**SUBJECT: The Sod Guy
Sales Lot
Drainage Letter – Lot 1 in Appaloosa Highway 24 Subdivision Filing No 1A**

PCD FILE NO. PPR1925

THE SOD GUY - SALES LOT
SITE PLAN

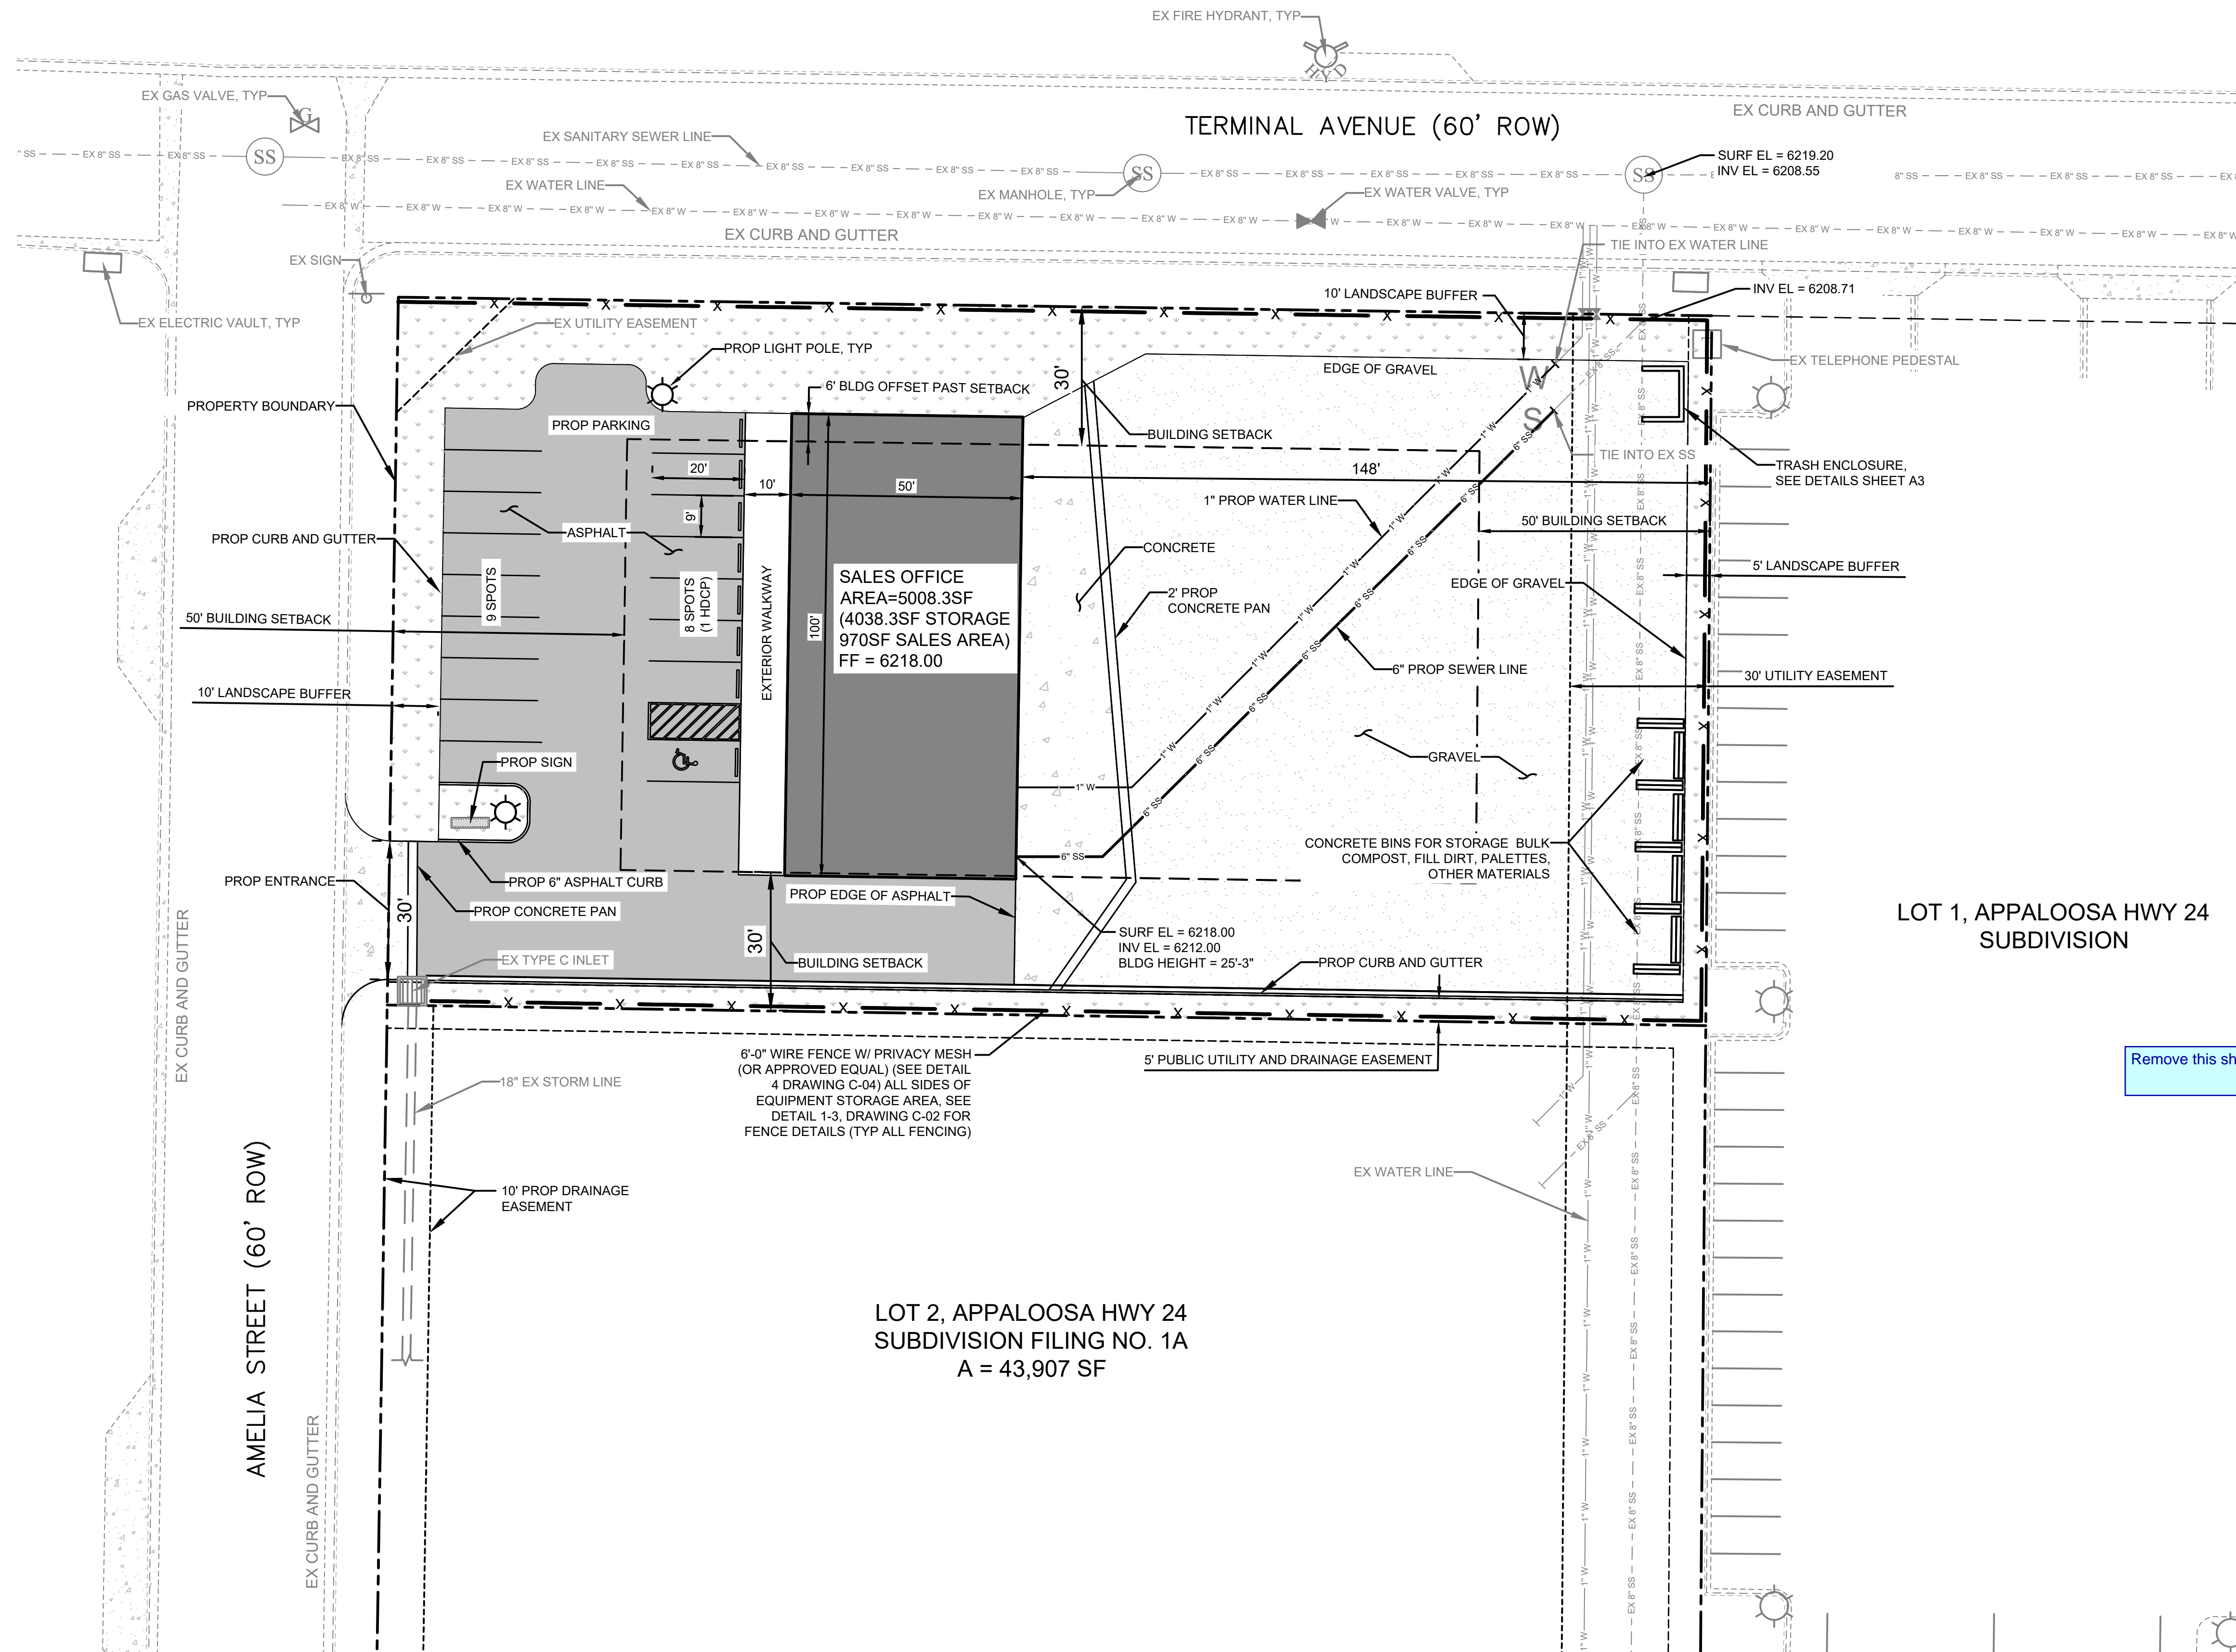
Remove this sheet from the drainage letter

FENCE DETAILS

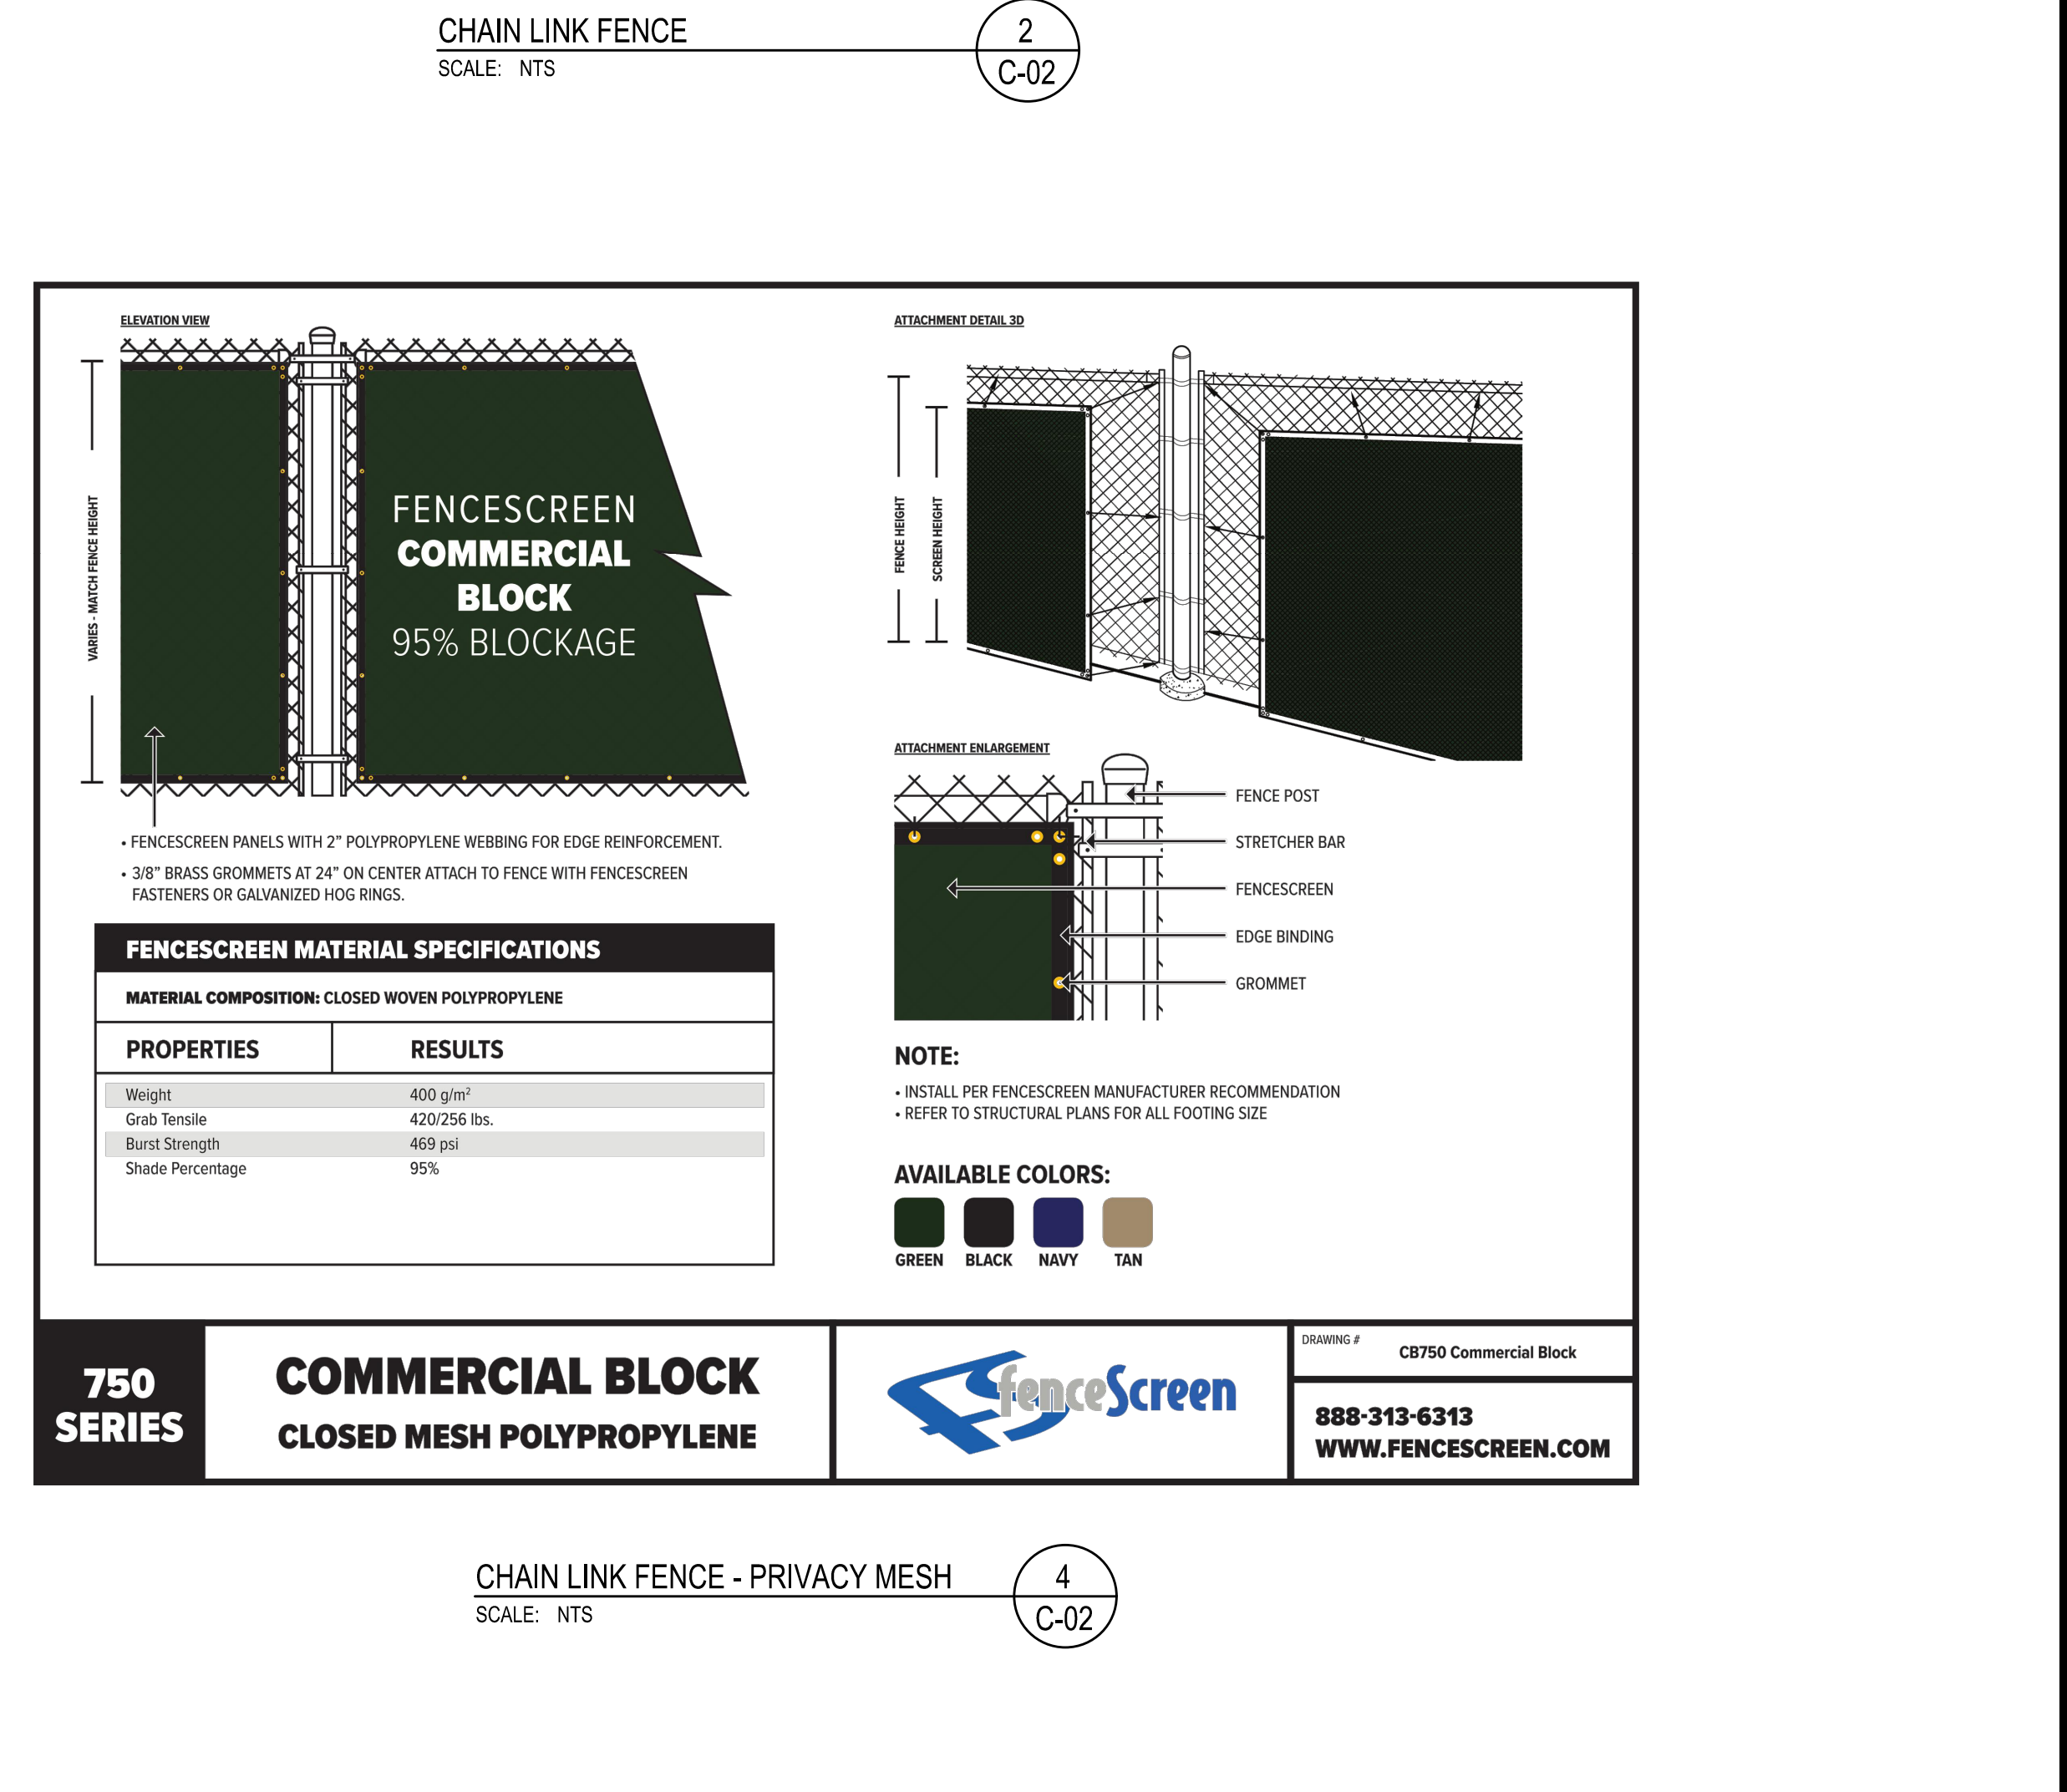
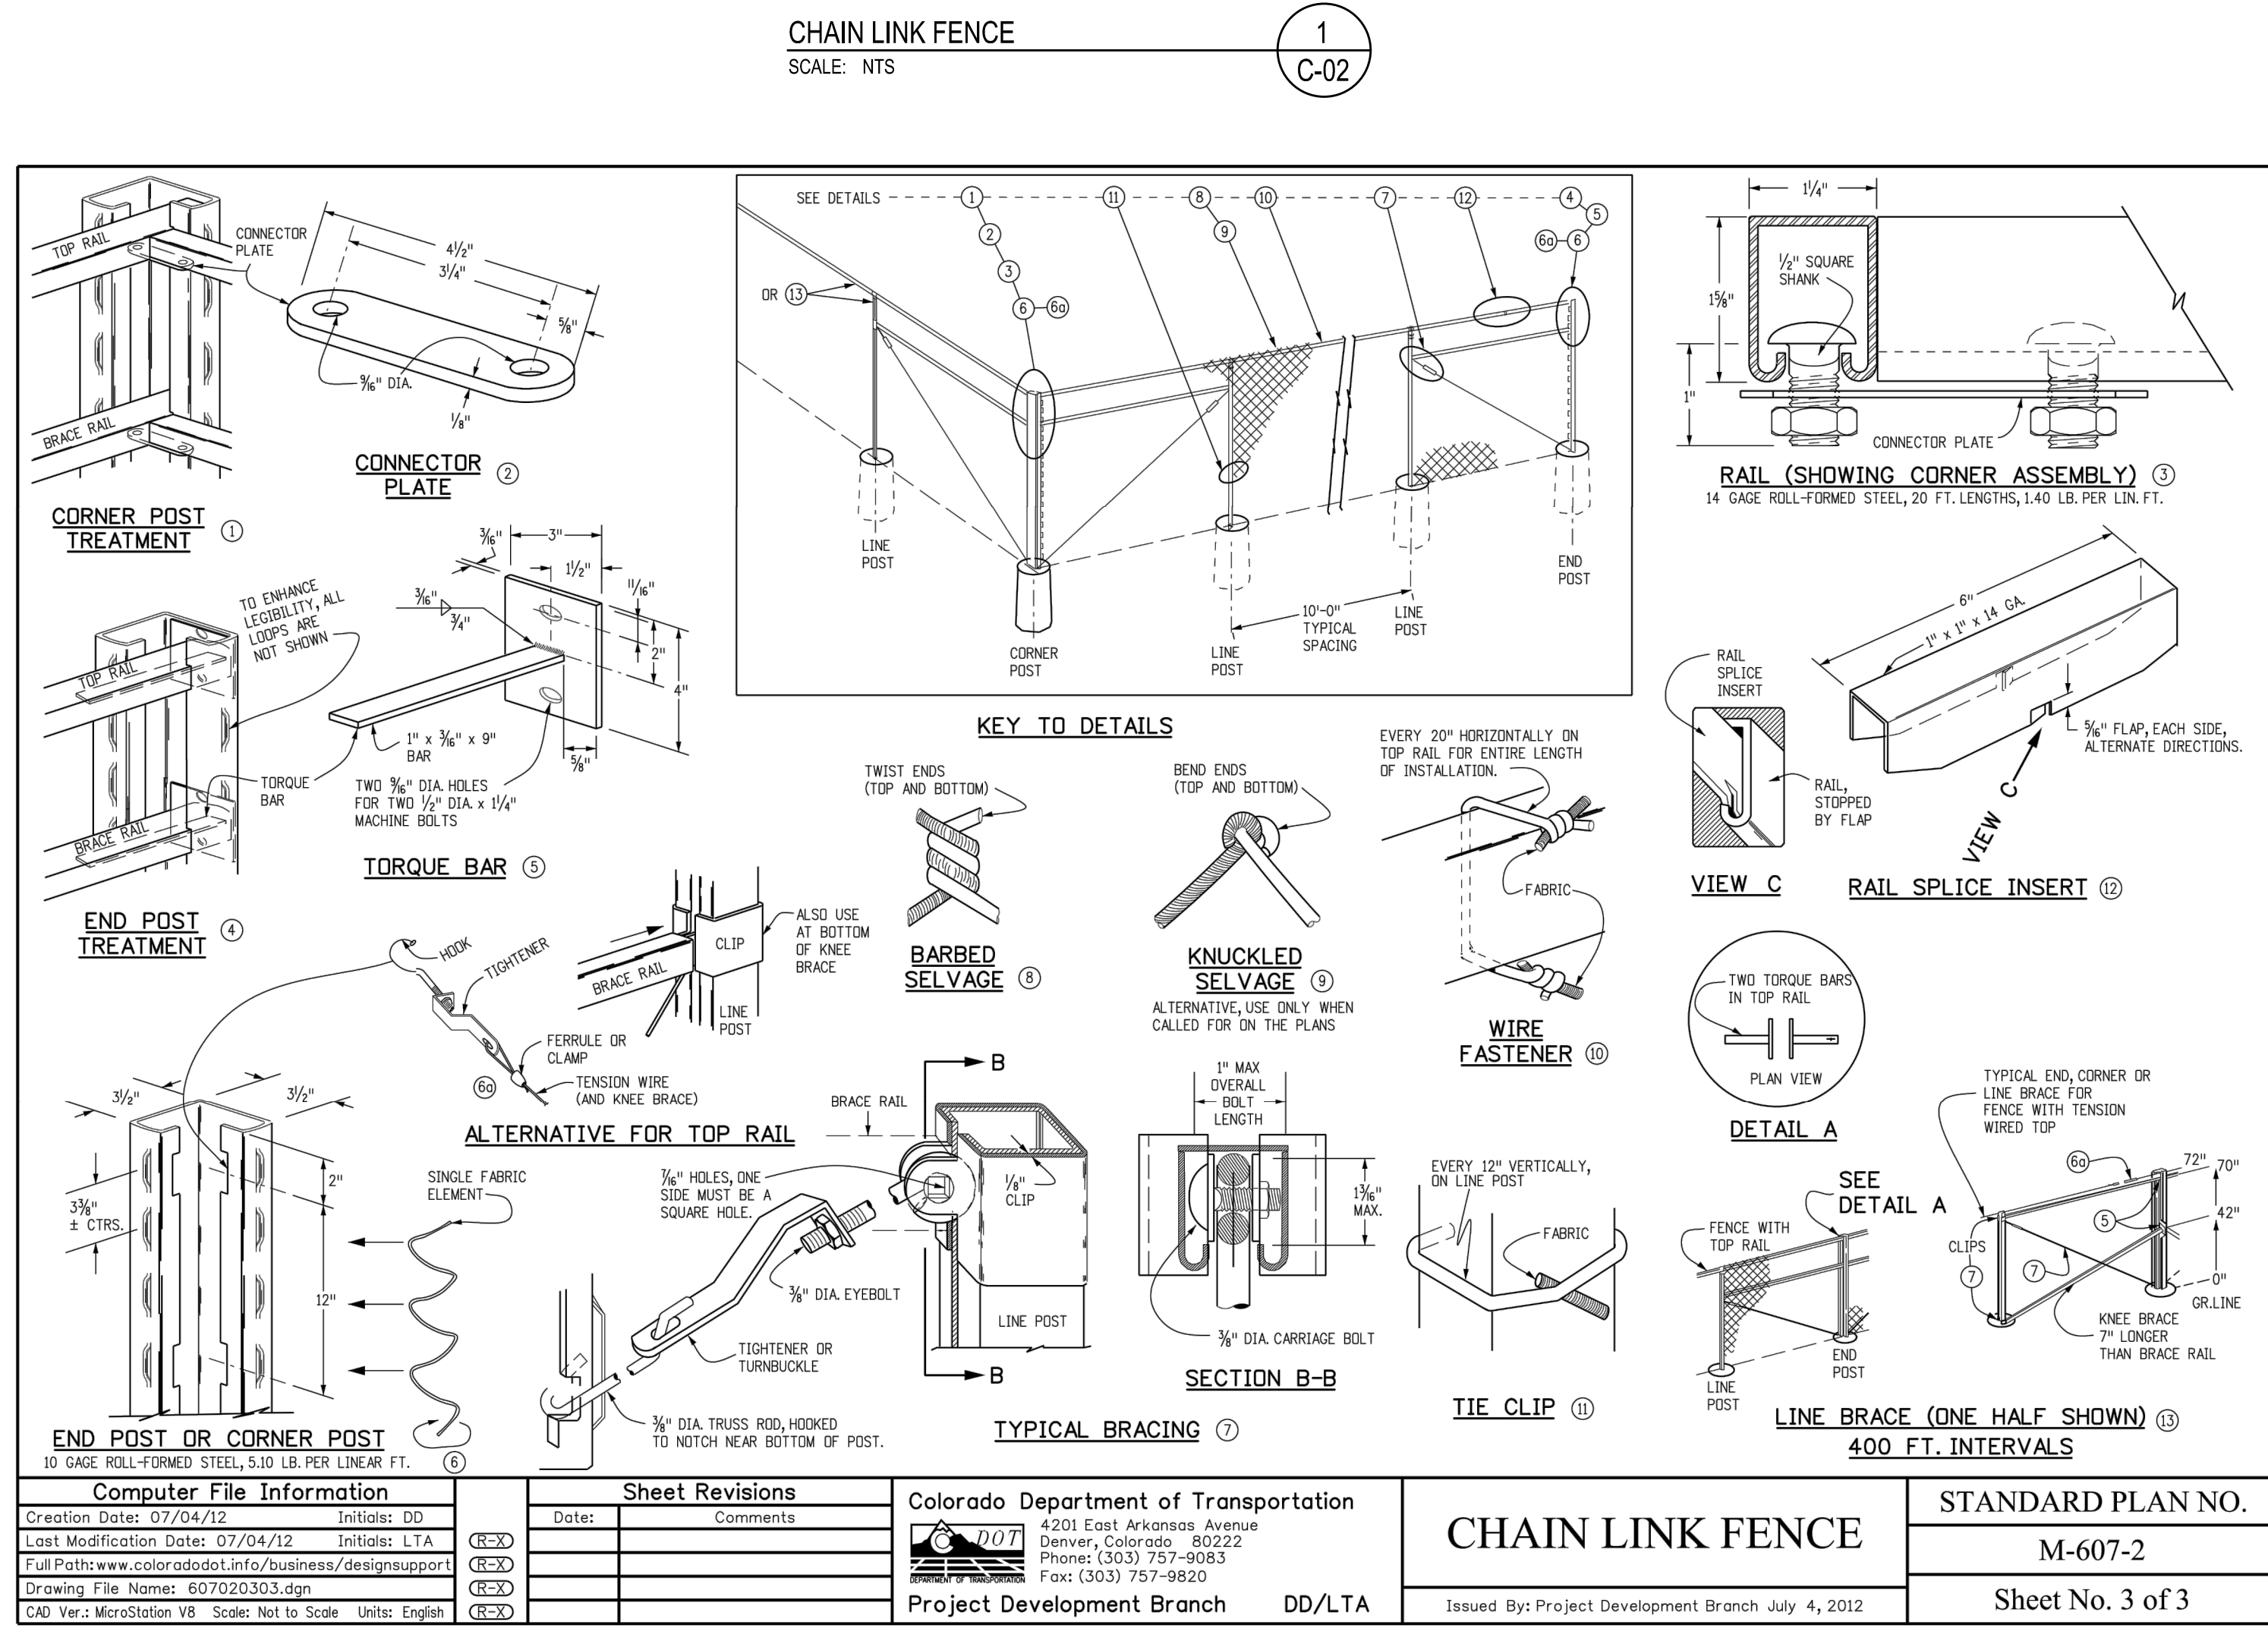
Remove this sheet from the drainage letter
